Work Order ID 77309

Item Name: Crosstube Turning Detail

DRAWING NO. D212-664-141	TITLE XTUBE ASSY (205/212/412 HI FWD)	REV. D	DART AEROSPACE LTD ENGINEERING ORDER		D.E.O. NO. D212-664-141-D-1	SHEET NO. SHEET 1 OF 2	SCALE NTS
DRAWN	CHECKED	MFG. APPR.	APPROVED	DE APPR.			
DATE 11.04.07	DATE 11.07.11	DATE 11.04.12	DATE 11/04/12	DATE 11.04.12

ADD AN INSPECTION WINDOW TO UNDERSIDE OF CROSSTUBE.

**D212-664-141/-141B
ASSEMBLY DETAIL**

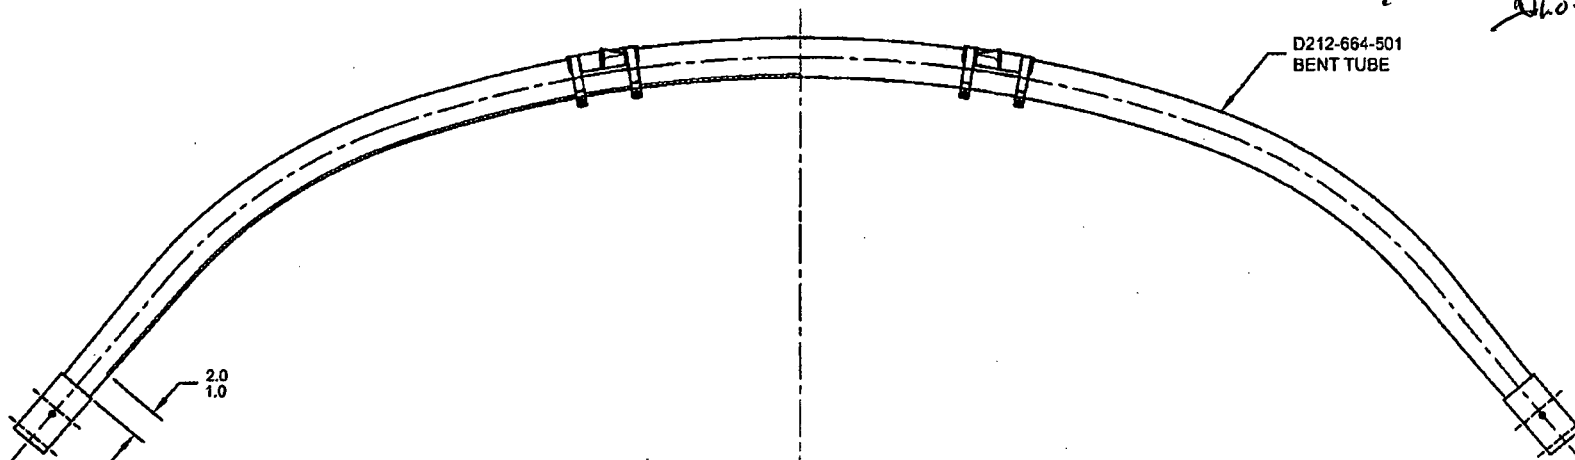
NOTES 2 OF SHEET 1 IS AMENDED AS FOLLOWS:

- 2) FINISH: CHEMICAL CONVERSION COAT PER DART QSI 005 4.1
PRIME INSIDE AND OUTSIDE PER DART QSI 005 4.2
MASK UNDERSIDE OF CROSSTUBE AS SHOWN (HATCHED AREA) AND
PAINT OUTSIDE PER DART QSI 005 4.2
REMOVE MASKING AND APPLY CLEAR COAT

- 2) FINISH: CHEMICAL CONVERSION COAT PER DART QSI 005 4.1
PRIME INSIDE AND OUTSIDE PER DART QSI 005 4.2
PAINT OUTSIDE PER DART QSI 005 4.2

MASK AREA PRIOR TO PAINTING,
REMOVE MASKING AFTER PAINT
AND APPLY CLEAR COAT
